To: Salt Lake City Historic Landmark Commission
From: Madison Blodgett, Principal Planner, madison.blodgett@slc.gov
Date: September 3, 2026
Re: PLNHLC2026-00368, Major Alteration at 378 N Quince St

Major Alteration

Review the revisions made to the Major Alteration request since the August 6th 2026, Historic Landmark Commission meeting, and make a decision on the request.

Response to Historic Landmark Commission Comments

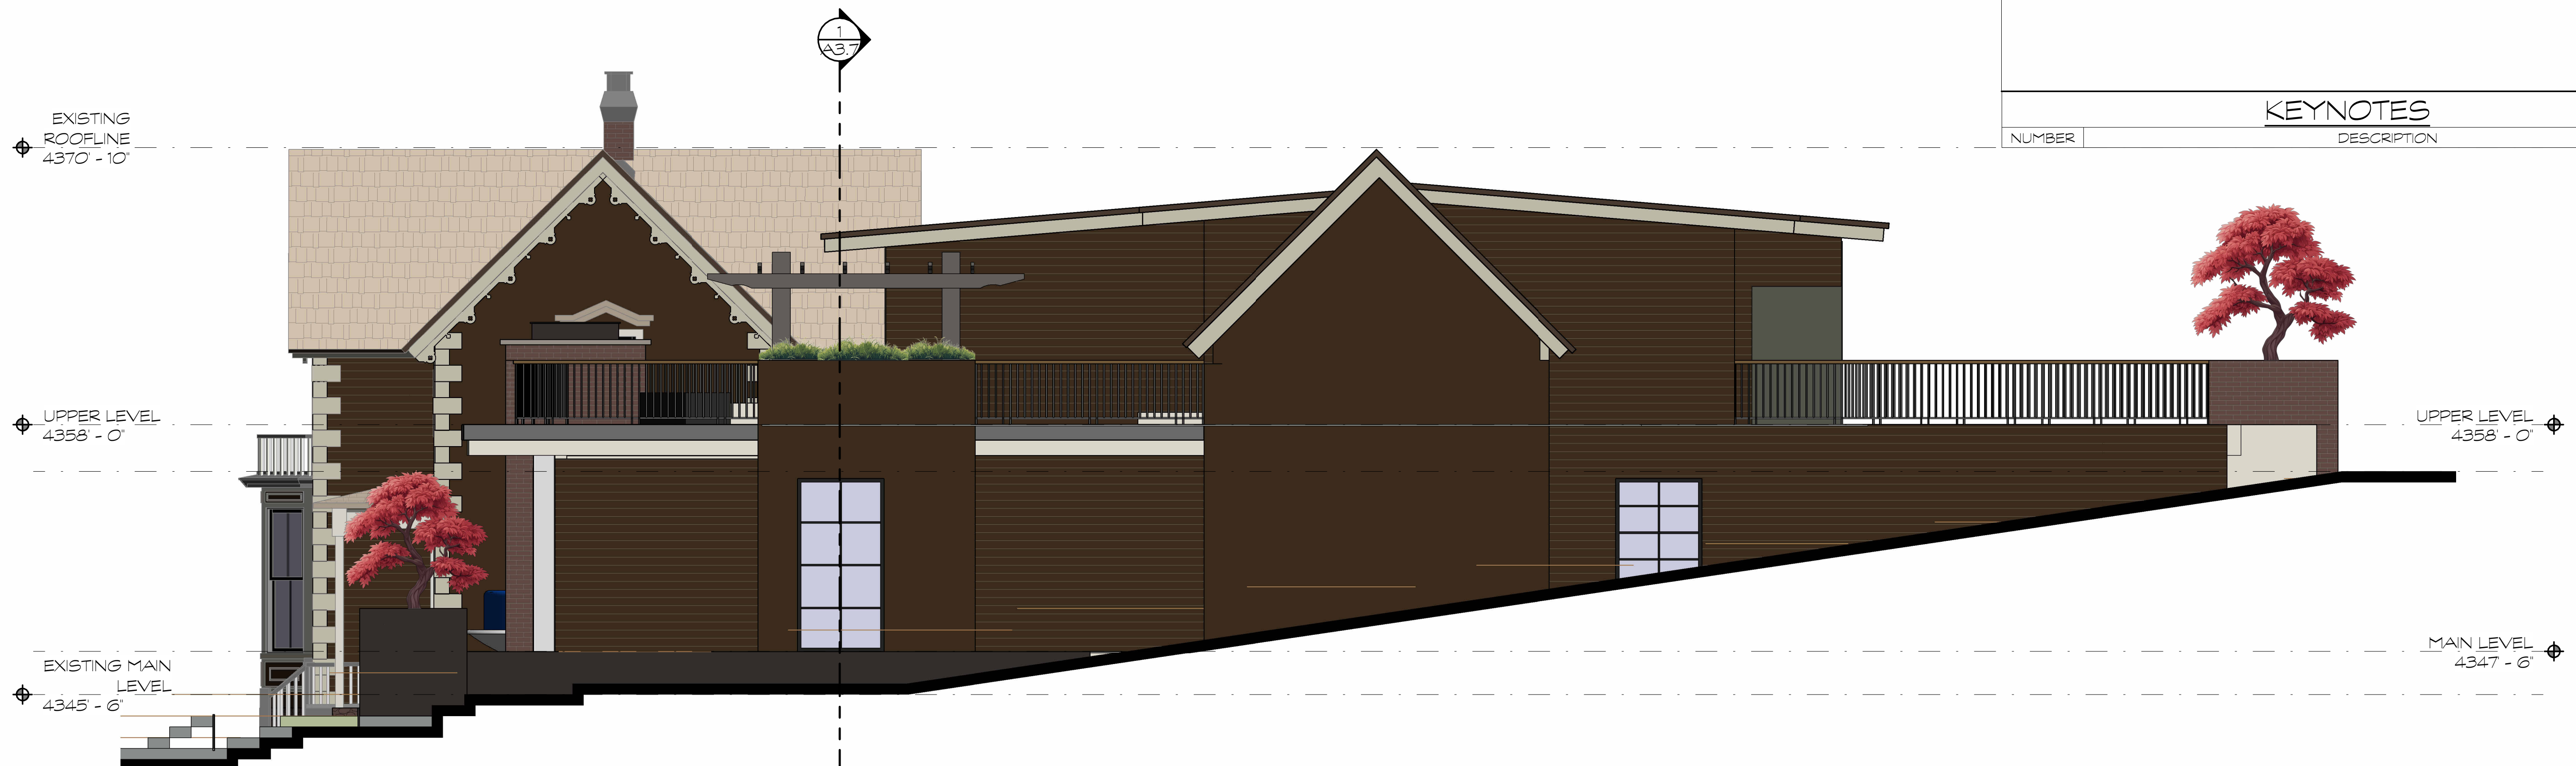
Compatibility of Scale, Color and Materials: Specifically, the scale of the brick planter on the public street facing elevation was found to be too visually prominent and not complementary to the existing house, which is primarily clad in wood siding. Concerns also included the proposed use of reclaimed barnwood and the extreme curvature of the front balcony.

REPLACED RECLAIMED SIDING WITH MATCHING PAINTED WOOD
REDUCED CRICK MATERIAL
PREVIOUS PLANTER TRANSLATED TO A FUNCTIONAL CHIMNEY
REDUCED RADIUS OF DECK (LESS SEVERE)
RAILING OF DECK NOW SET BACK 24" TO REDUCE FOCAL WEIGHT
